**RE: Sundance Construction – Beverly Hills
Grading and Drainage Plan
Engineer’s Stamp Date: 01/24/18
Hydrology File: B18D023**

Based upon the information provided in your submittal received 01/24/18, the Grading and Drainage Plan **is not** approved for Building Permit. The following comments need to be addressed for approval of the above referenced project:

C-100

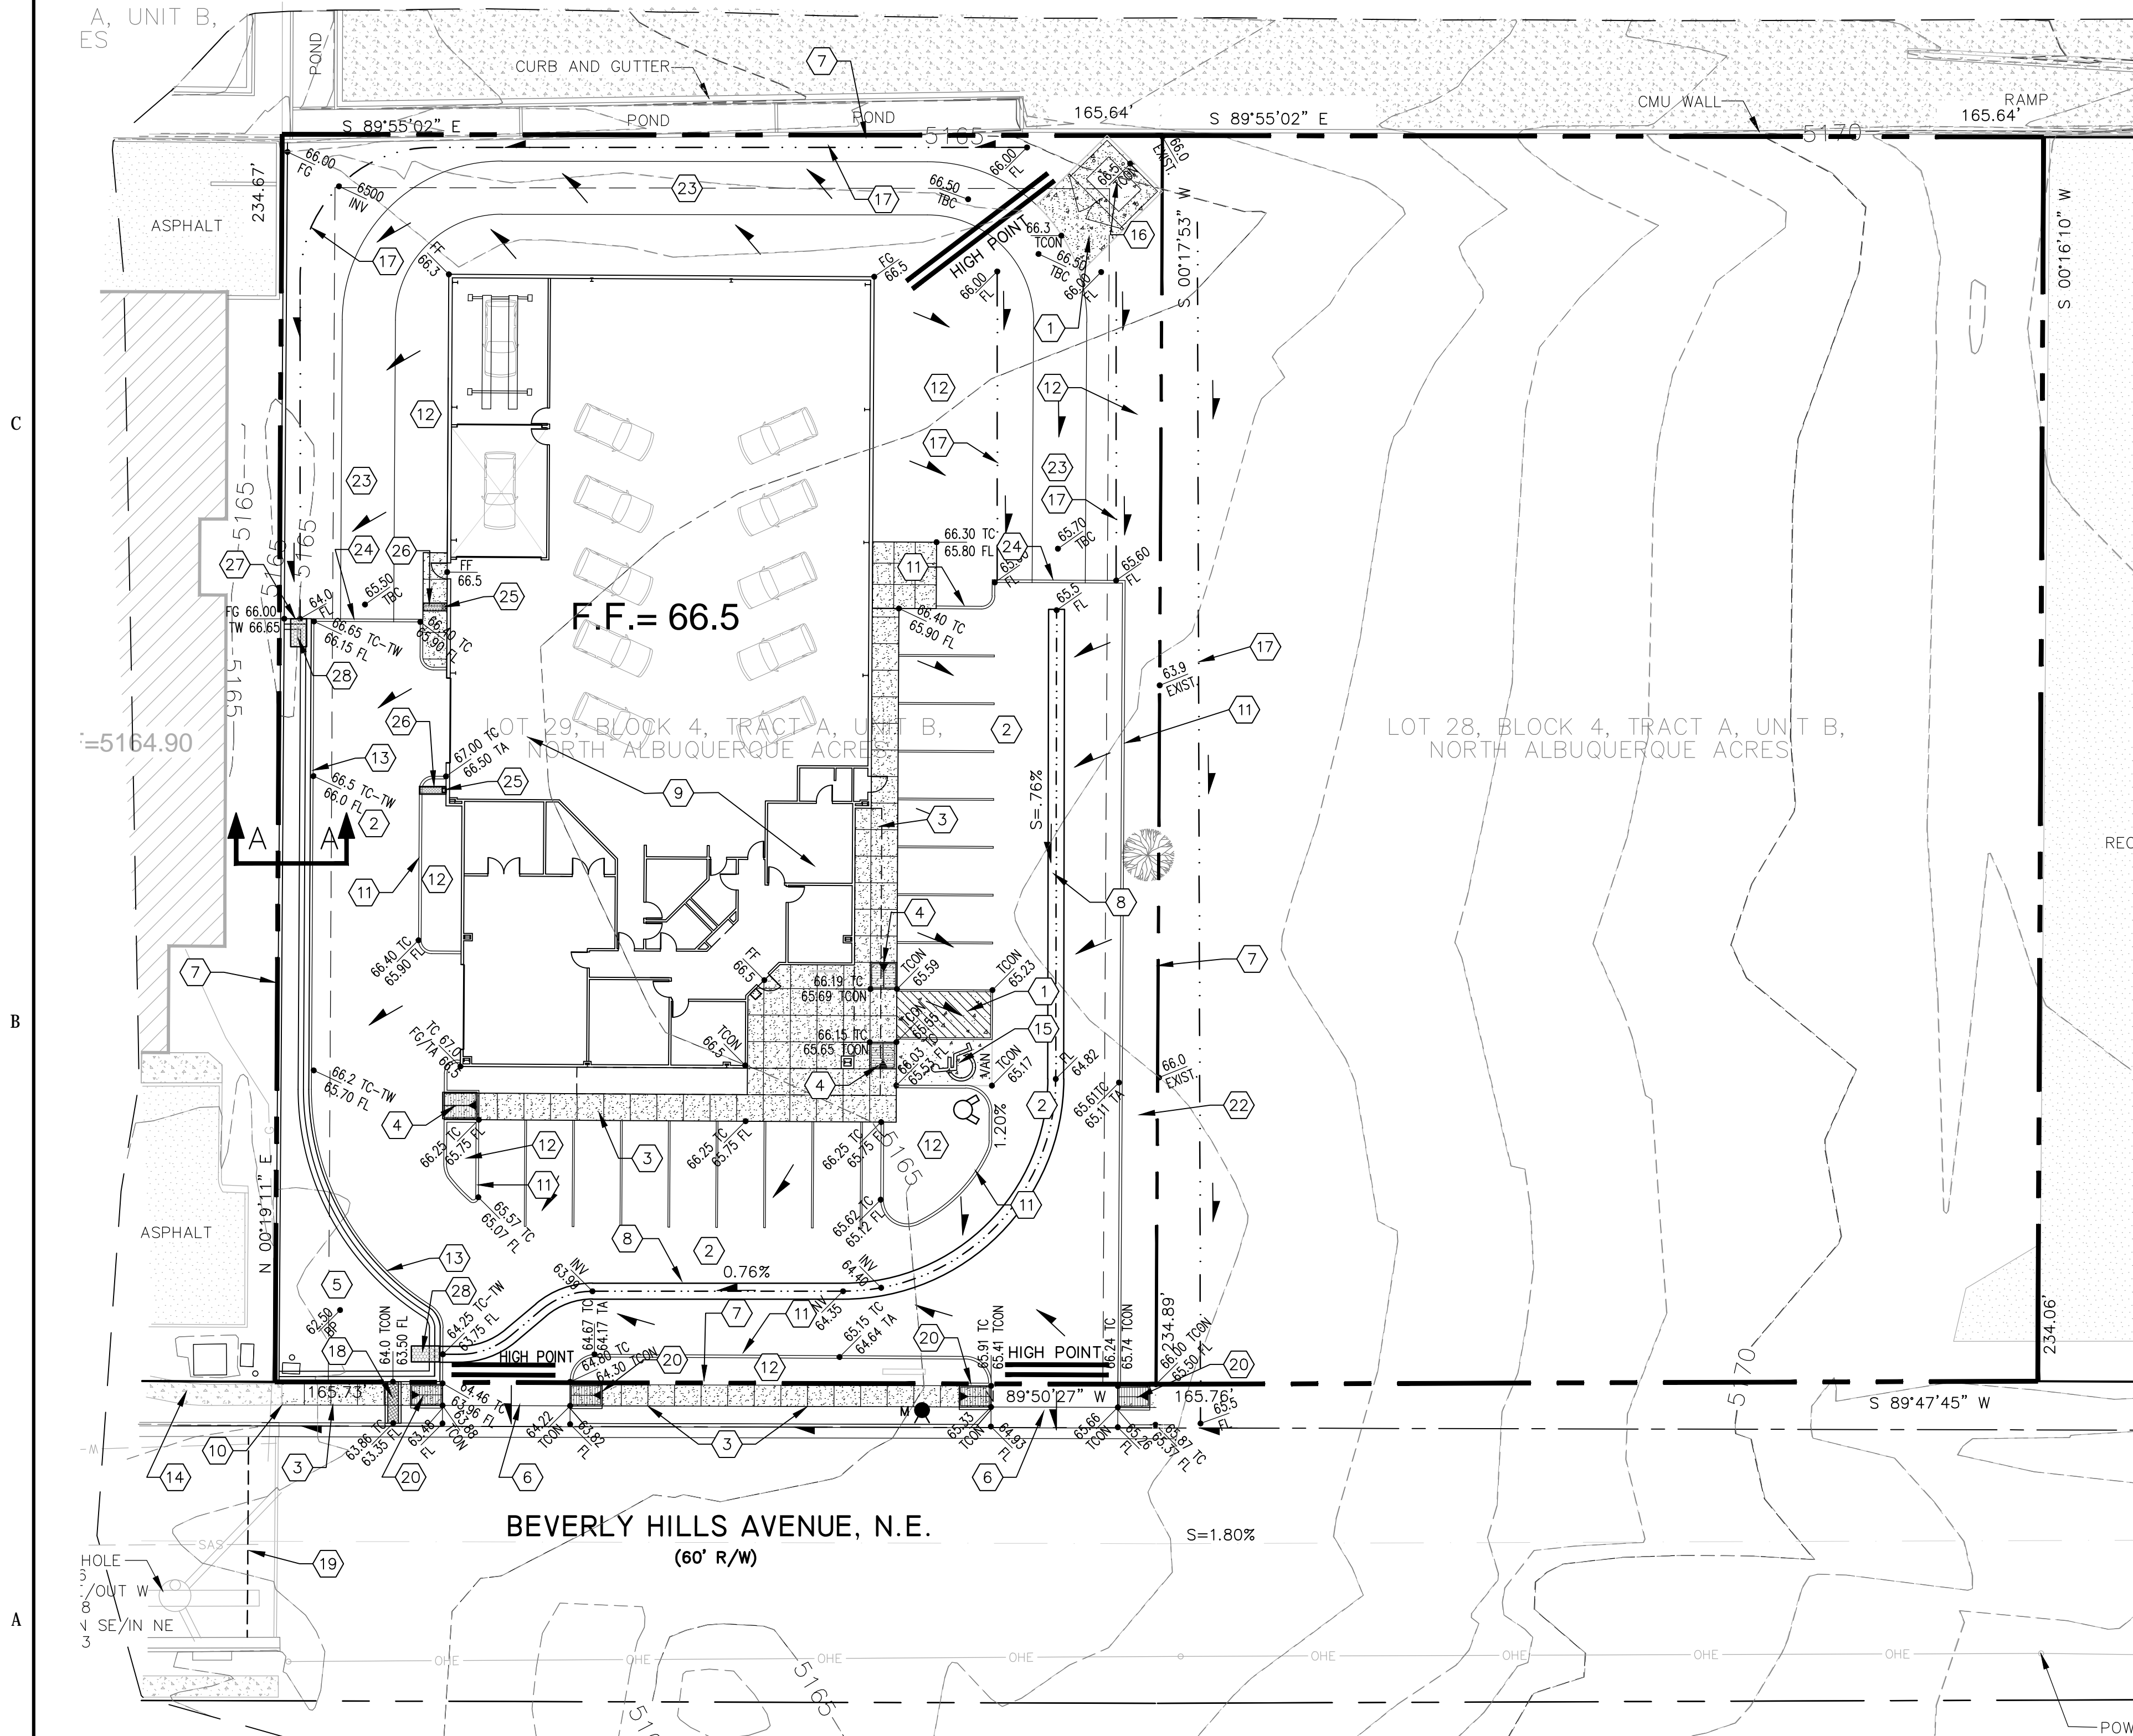
1. Sheet C-100. Please provide the weir calculations for the curb cuts.
2. Sheet C-101. Key Note 7 states approximate location of property line. All property lines and existing topographic survey information must be accurate and not approximated. At the northwest corner, it appears that the adjacent pond is on this property. Please submit a surveyed property. If the property lines are properly surveyed, then delete the word approximate location of property line from Key Note 7.

SECTION AA

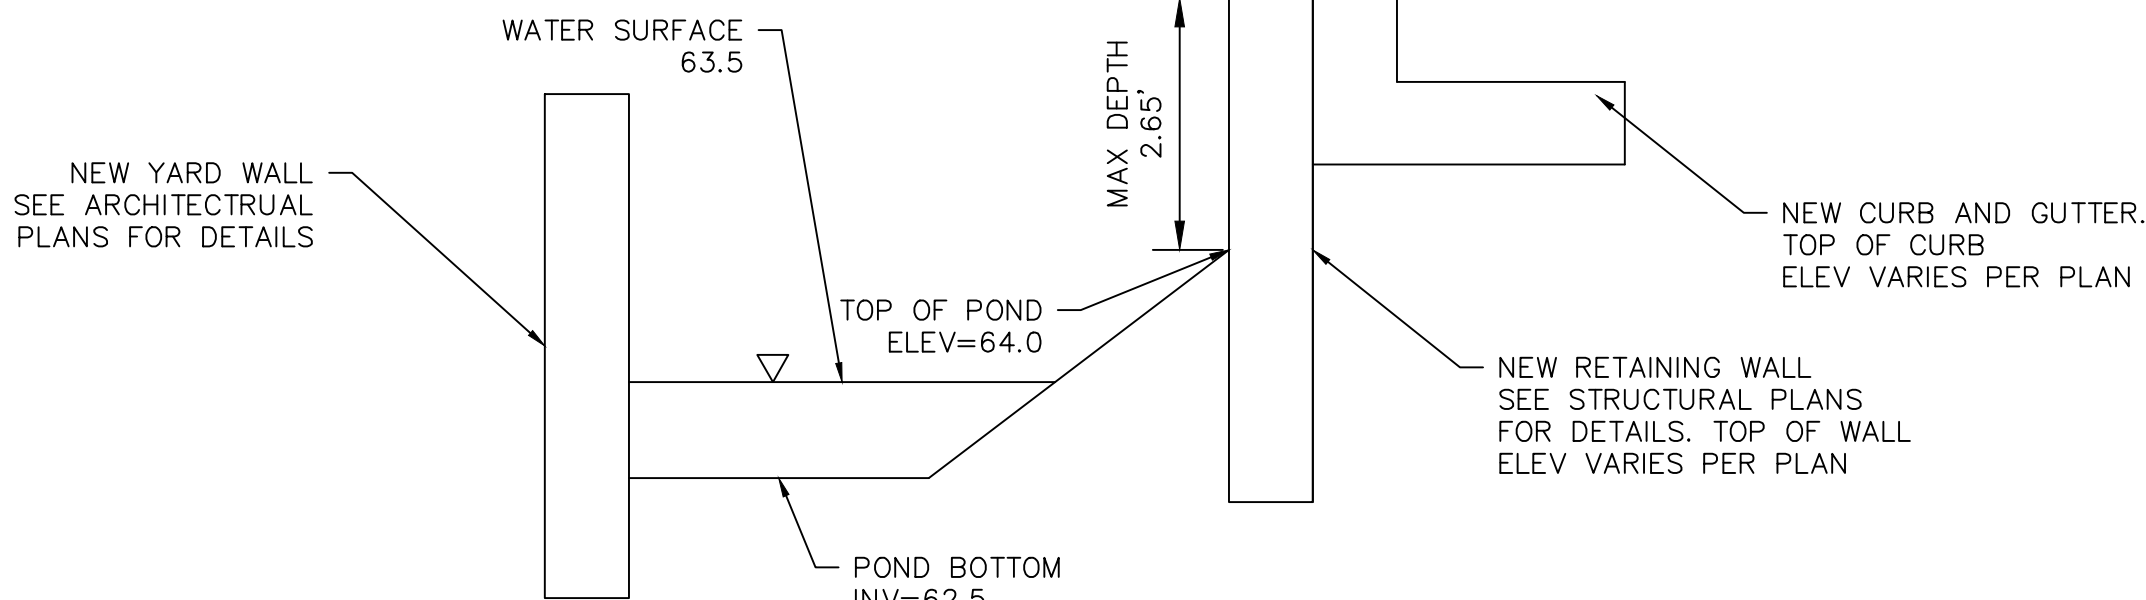
6. Sheet C-101, Section A-A. Please show the property line and dimension of the wall from the property line.
7. Sheet C-101, Section A-A. Per DPM Ch. 22.5.B, grading and construction of retaining walls at or near the property line must demonstrate that the adjacent property is not damaged or its use constrained. Any such encroachment by the wall or grading must be accompanied by written permission of both landowners. Therefore the wall may have to be moved away so that the footer does not impede the adjacent property.
